AIR RESEARCH TECHNOLOGY INC. WINGX STOL

SERVICE BULLETIN

Number SB-1-96 April 11, 1996

Lower Main Spar Cap at Wing Station 100.00

FIGURE 1 - Spar Construction Detail

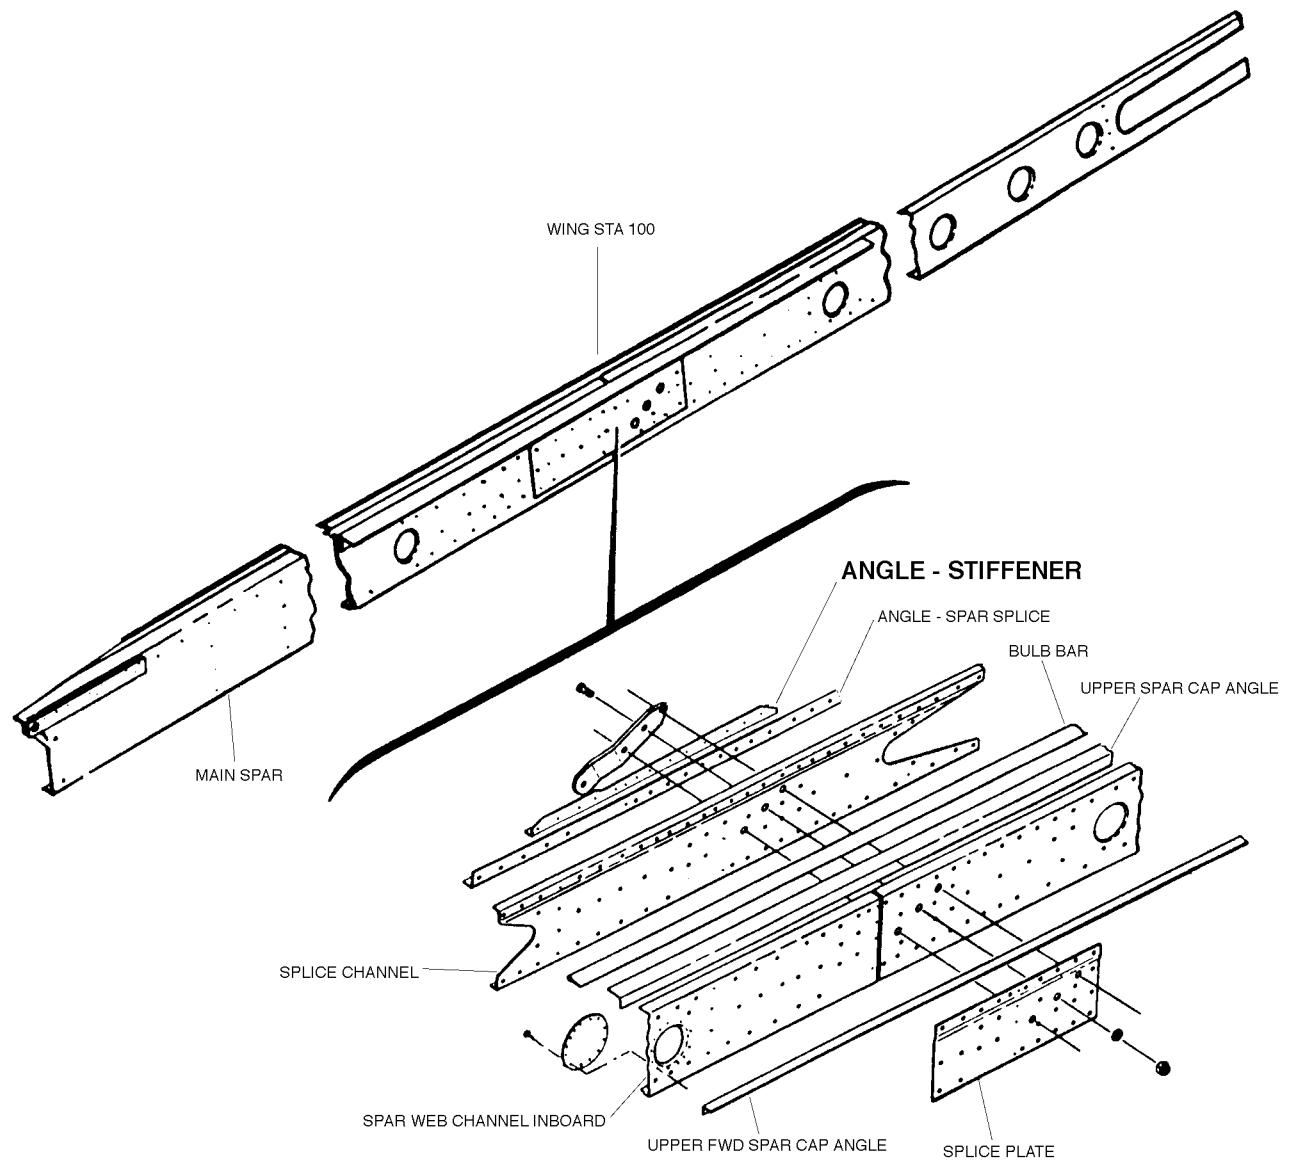
1) Open the inspection hole situated on the underside of the wing, aft of the spar, closest to where the strut connects to the wing. Using a flashlight and a mirror, by visual inspection, ascertain if the subject wing has the "*angle stiffener*" installed along the lower spar cap between Wing Station 90 and 110 (approximately).

Refer to Figures 1 and 2 to assist identification of the "*angle stiffener*".

FIGURE 2 - Spar Section Detail
WING STATION 100
Wing with Angle Stiffener Installed

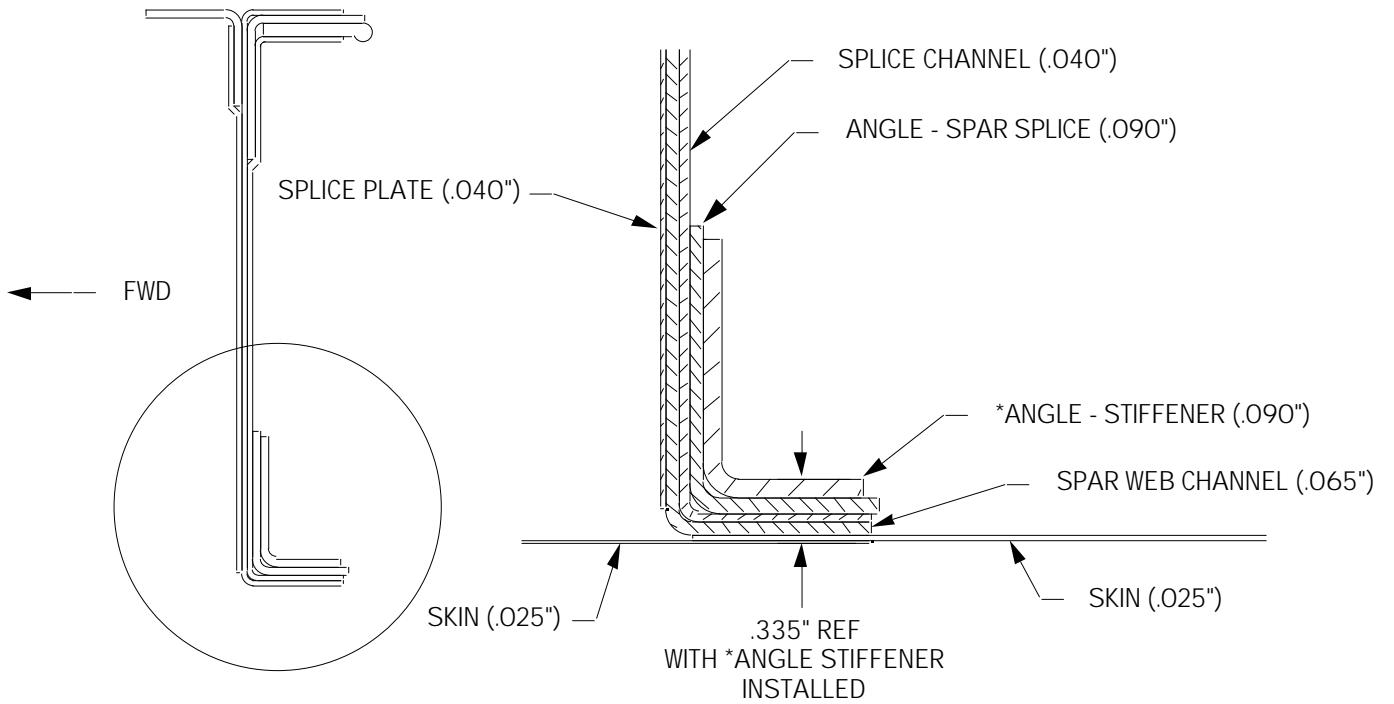
3) The installation of the Stainless Steel Strap 0.077" in accordance with Part B of this Bulletin is **MANDATORY** on wings which do not incorporate the "*angle stiffener*".

FIGURE 3 - Spar Section Detail
Wing without Angle Stiffener Installed after Part B Modification

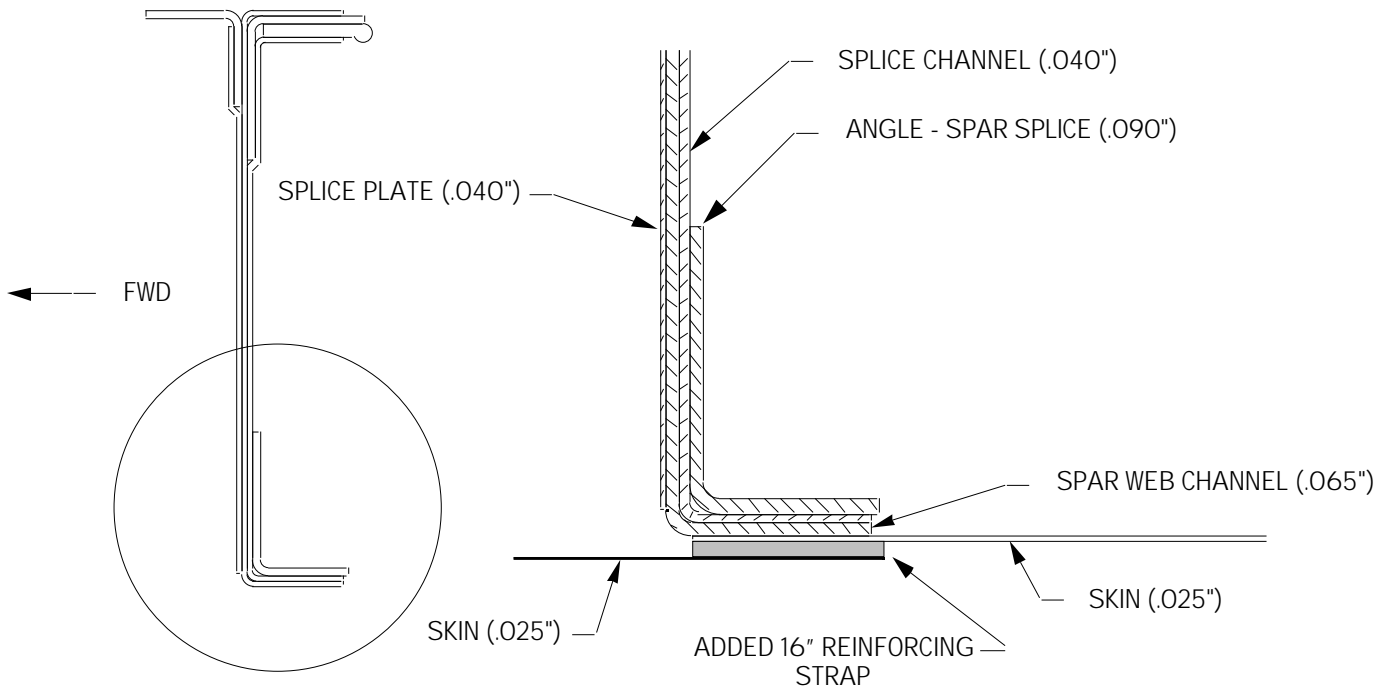
Early model wings on the affected aircraft do not incorporate an angle stiffener at the spar splice at wing station 100.00. Static testing performed by A.R.T. has shown that these modified wings do not satisfy the applicable design requirements. The modification introduced by this Bulletin corrects this deficiency.

Part B consists of installation of a reinforcing strap. If the "*angle stiffener*" is not present Part B must be accomplished.

6) Slide the "s/s strap" under the leading edge wing skins and up against the underwing skin along the spar channel and then center the "s/s strap" at Wing Station 100.50.

A) The number of holes to be drilled may vary with different aircraft however (7) rivets on each side of the spar splice at Wing Station 100.50 is the minimum required in order to obtain the desired structural strength of the spar splice.

B) The hole positions, as marked may not align perfectly down the center of your "s/s strap". This is normal; however, a rivet edge distance of .375" must be maintained on the "s/s strap".

A) At Wing Station 100.25 "the leading edge lap joint", install (1) rivet No: CR3213-6-7 universal head CherryMAX rivet " DO NOT SUBSTITUTE ". This longer rivet will allow for the additional thickness at the joint due to leading edge skins overlapping at this point as well as the additional thickness of the center rib at this position.
